THE LOFTS AT ST. EMANUEL SUBDIVISION

APPLICATION NUMBER 8 DATE April 19, 2018

REQUEST Subdivision

DETAIL SITE PLAN

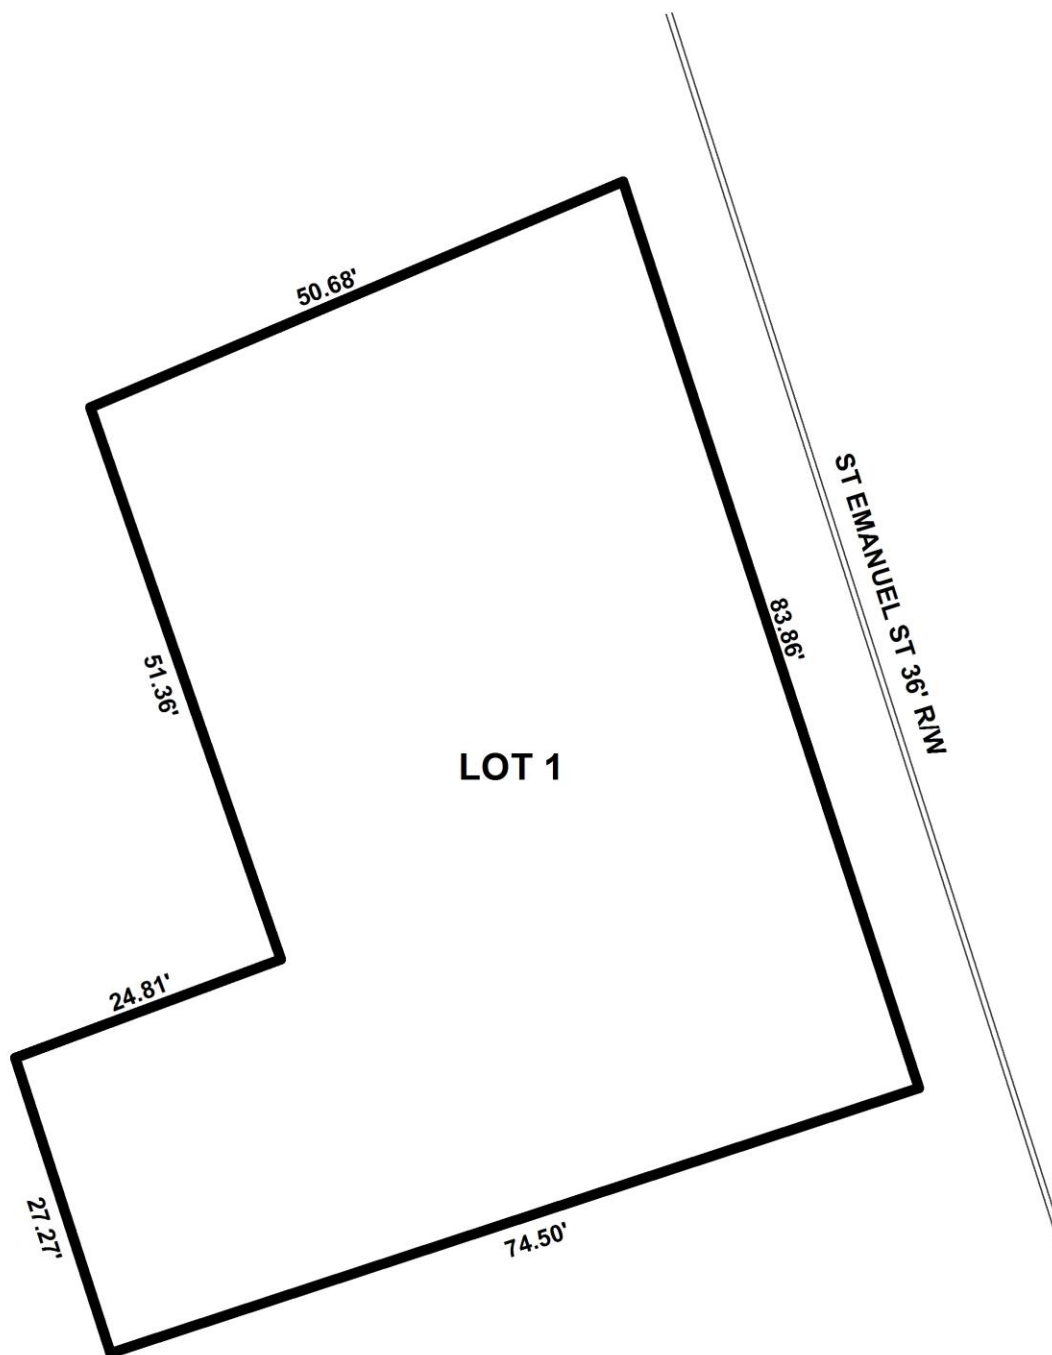
There are no building setback lines illustrated on the preliminary plat. The DDD, per Section 64-3.I.8.(d), allows from 0' minimum to 12' maximum setback along all street frontages. If approved, the Final Plat should be revised to illustrate a 12' maximum building setback line along all street frontages, with a note stating a 0' minimum is allowed.

The DDD requires a parking setback of at least the building setback for T-5.2 Sub-districts per Section 64-3.I.8.(d) of the DDD code. If approved, a note should be placed on the Final Plat indicating that if parking is provided in the future, a parking setback of at least the building setback will be required.

The proposed lot does not meet the 7,200 square foot minimum lot size requirements of Section V.D.2. of the Subdivision Regulations for lots served by public water and sanitary sewer systems. However, it should be noted that there is no minimum lot area requirement for lots within the DDD. The preliminary plat provides the lot sizes in square feet and in acres. If approved, the lot size information should be retained in both square feet and acres on the Final Plat.

As a means of access management, a note should be placed on the Final Plat, if approved, stating that Lot 1 is limited to one curb cut, with size, location and design to be approved by Traffic Engineering and conform to AASHTO standards.

- 1) Retention of the 36' right-of-way width to St. Emanuel Street;
- 2) Illustration of a 12' maximum building setback line along all street frontages, with a note stating that 0' minimum building setback is allowed;

- 3) Retention of lot size information in both square feet and acres;
- 4) Placement of a note on the Final Plat stating that Lot 1 is limited to one curb cut per street frontage, with size, location and design to be approved by Traffic Engineering and conform to AASHTO standards.

- 5) Placement of a note stating that if parking is provided in the future, a parking setback of at least the building setback will be required.
- 6) Compliance with Engineering comments: (*FINAL PLAT COMMENTS (should be addressed prior to submitting the FINAL PLAT for review and/or signature by the City Engineer): A. Provide all of the required information on the SUBDIVISION PLAT (i.e. signature blocks, signatures, certification statements, written legal description, required notes, legend, scale, bearings and distances) that is required by the current Alabama State Board of Licensure for Professional Engineers and Land Surveyors. B. Revise the written legal description to include the proposed subdivision boundary. C. Show and*
